**RE: V-002-0005 Variance; MD Rte 18, 800 Main St, Stevensville
Ramshead Restaurant**

IN THE MATTER OF * BOARD OF APPEALS
THE APPLICATION OF * OF
J&B PROPERTY HOLDINGS, LLC * QUEEN ANNE'S COUNTY
* Case No. V-020005

FINDINGS AND DECISION

**RE: BOARD OF APPEALS CASE NO. V-020005
VARIANCE FOR STAIRCASE AT RAMSHEAD RESTAURANT
VARIANCE FROM PAVING REQUIREMENTS**

PROPOSED ADDITIONS
 FOR
RAMSHEAD
 TAX MAP 56, PARCEL 65
 QUEEN ANNE'S COUNTY, MARYLAND

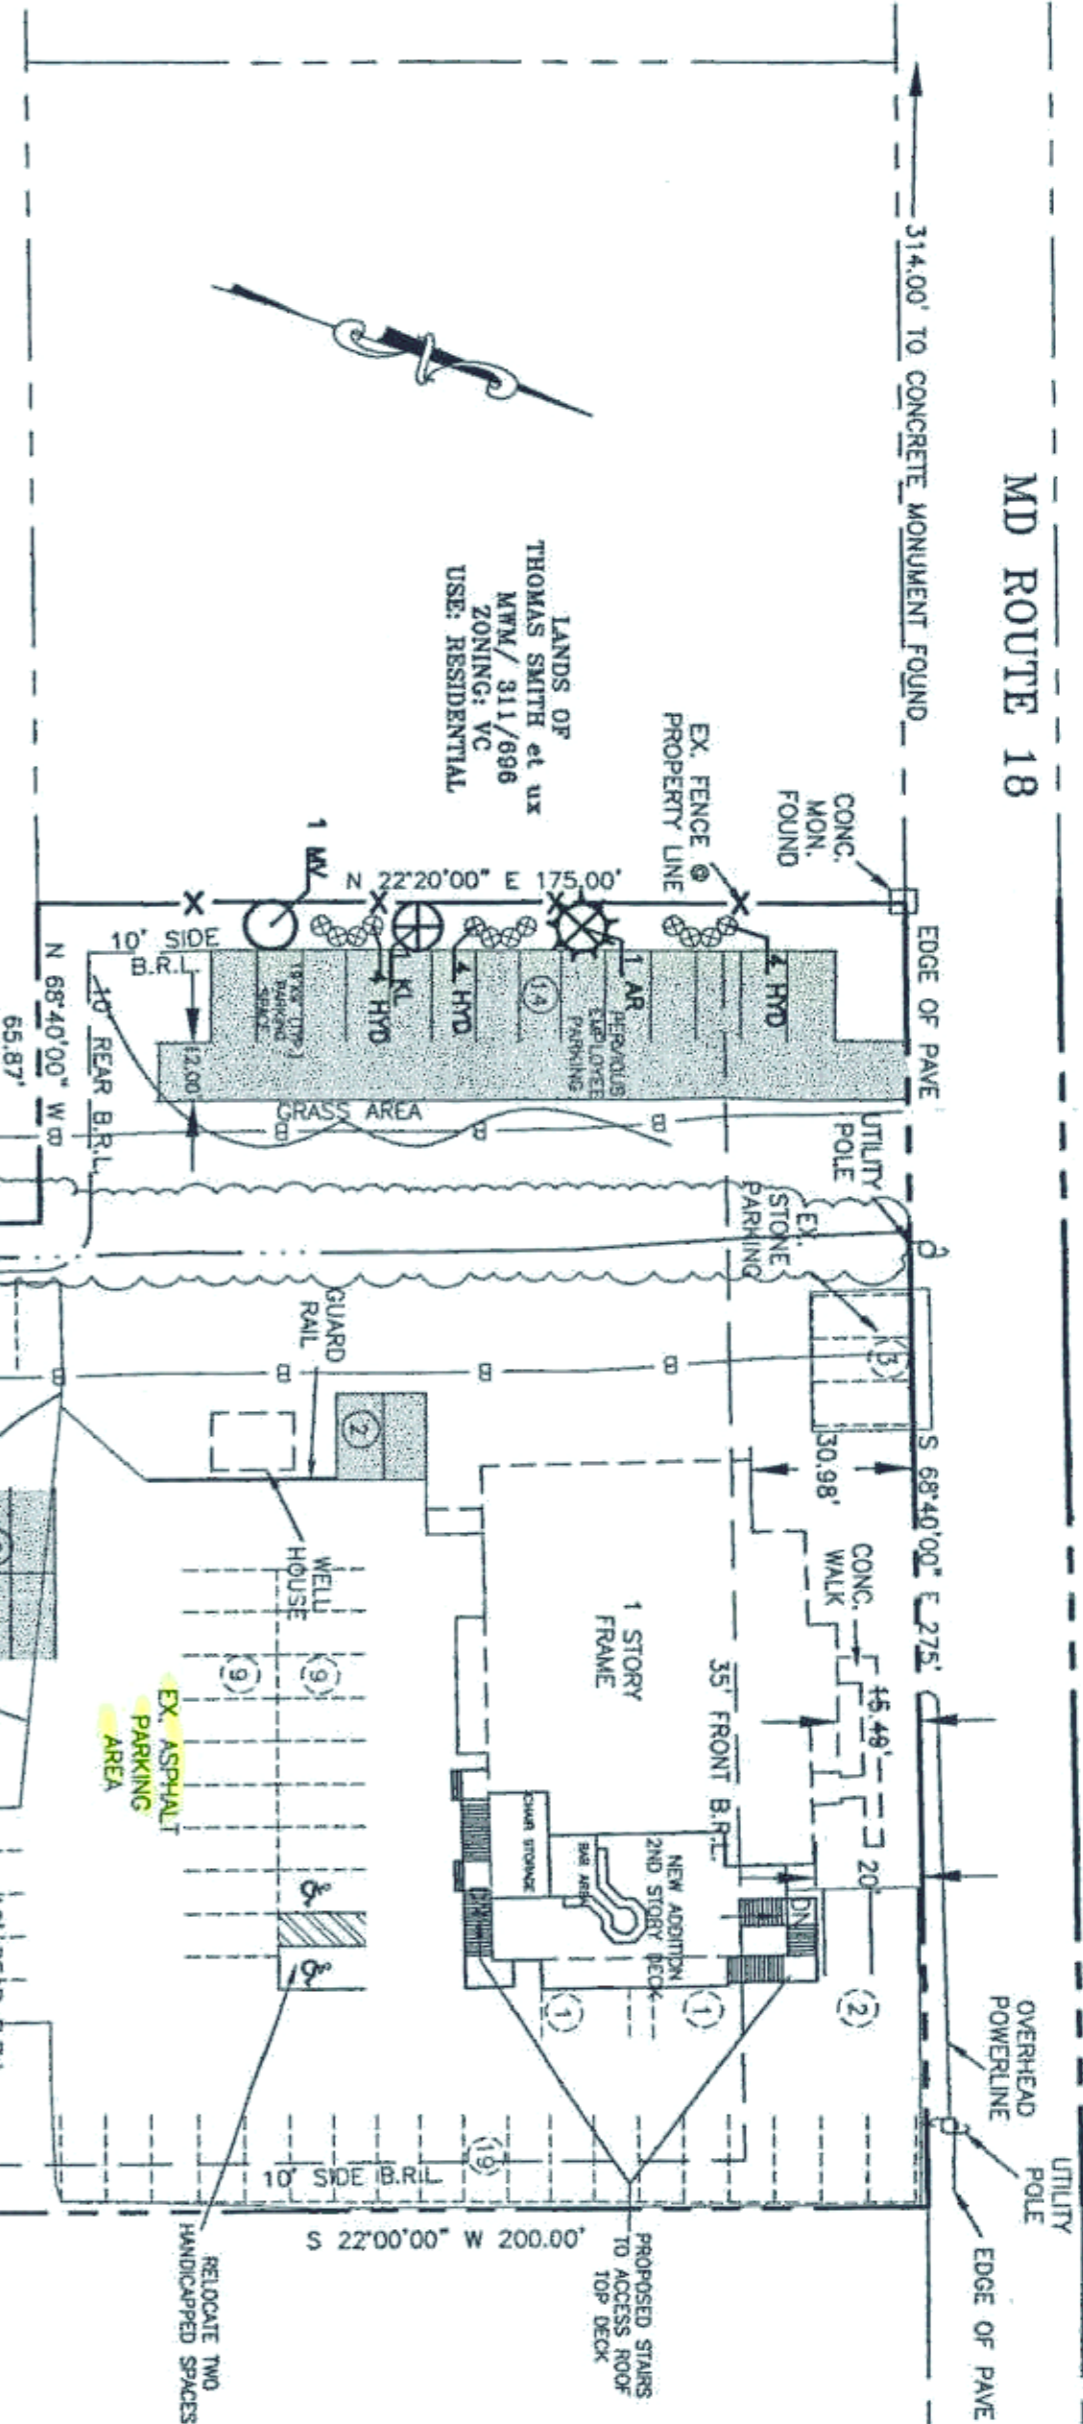
1. The 100 foot Critical Area Buffer line is 100 feet landward of the edge of the tidal wetlands. On the submitted plans, the 100-foot Critical Area Buffer is shown at the rear of the site. Notes on the plan indicate that MDE determined the location of tidal versus nontidal wetlands. The notes also state that the nontidal wetland is approximately 340 feet south of MD Route 18, and that the wetlands were not field verified for the plans. There appears to be a tidal wetland extending around the entire east/northeast side of the site. Because the applicant is proposing paving of the parking lot and other development activities that may be within the Buffer, the wetland must be professionally delineated and the Buffer field verified. Please have the applicant document who delineated the wetlands and what methods were used to delineate tidal versus non tidal. If the proposed work is within the Buffer and does not meet the standards of County Code § 14:1-51, a variance is necessary and the applicant must address the criteria of the County Code §14:1-68.

Any proposed pavement would require environmental field study to establish tidal wetlands limits to determine if the 100' buffer impacts the site (please refer to Critical Area Comments). If the proposed paving is located within the 100' buffer, it will require Critical Area variance. The owner desires to keep the parking lot as is (gravel), so as not to increase the impervious area within the Critical Area, hence a variance to § 18: 1 -83 O Paving Requirement of the Queen Anne's County Code under § 18: 1 -121 is sought.
